ONS-2018-016

**Subject:** Duke Energy Responses to Request for Additional Information (RAI); Request for Alternative to Codes and Standards Requirements Pursuant to 10 CFR 50.55a(z) to Satisfy 10 CFR 50.55a(h)(2) Associated with Bronze Tape Wrapped Emergency Power Cables in Use at the Oconee Nuclear Station

**Duke Energy Response to NRC Request for Additional Information**

DUKE ENERGY  
HEWLEE STATION  
ONE LINE DIAGRAM  
600 VOLT  
STATION AUXILIARY CIRCUITS

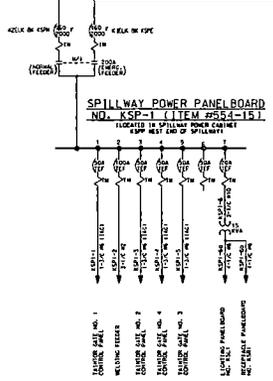
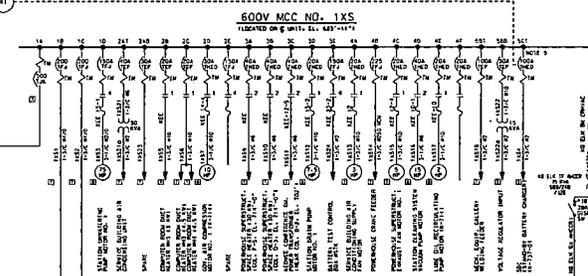
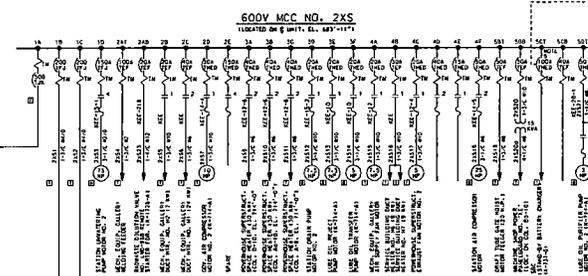
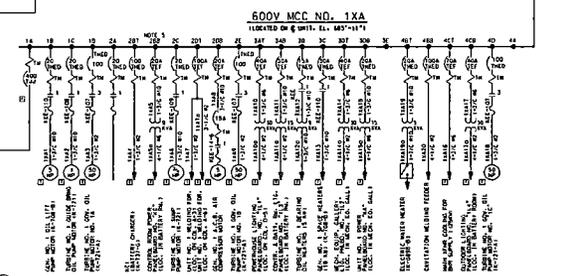
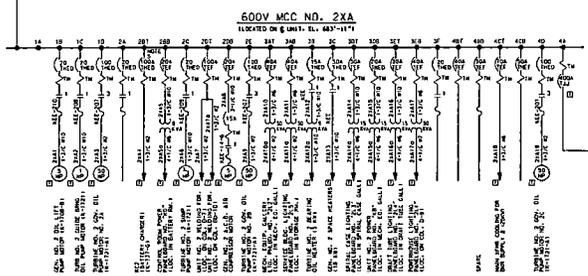
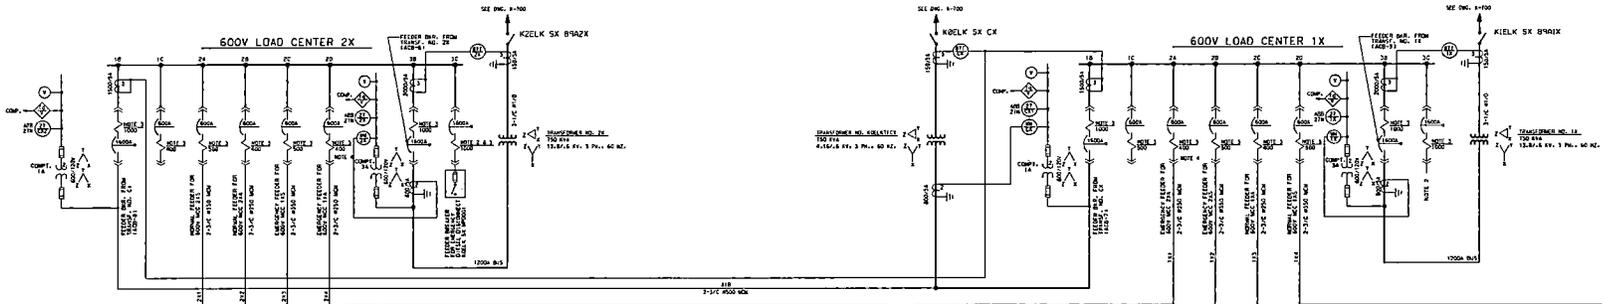
The staff requests the licensee to provide electrical single line diagrams that show the interconnections of the following switchgears and transformers discussed in the application: CT 4 transformer, KPF switchgear, 1TC switchgear, CX transformer, B6T switchgear, PX13 transformer, and PCB-9.

The requested equipment can be found on the drawings contained in this attachment:

- KPF Breakers are found on K-700 coordinates E-7, 8, and D-7, 8,
- CX transformer (Keowee Aux Power feeder) is found on K-702 coordinates K-8 and K-700 coordinates H-13,
- PCB-9 (Keowee 230KV Switchyard breaker) is found on O-800 coordinates E-8,
- Switchgear 1TC-4 (Keowee Aux Power feeder CX) is found on O-702 coordinates H-4,
- CT-4 (Emergency Power Transformer fed from Keowee Underground) one-line and three-line diagrams are found on O-800-D coordinates E-3 and I-8, respectively,
- B6T (PSW Switchgear) is found on O-6700 coordinates G-5; Interconnections to KPF breakers are shown at coordinates L-5, and
- PX13 (4KV/600V transformer and Load Center) are shown on O-6707.
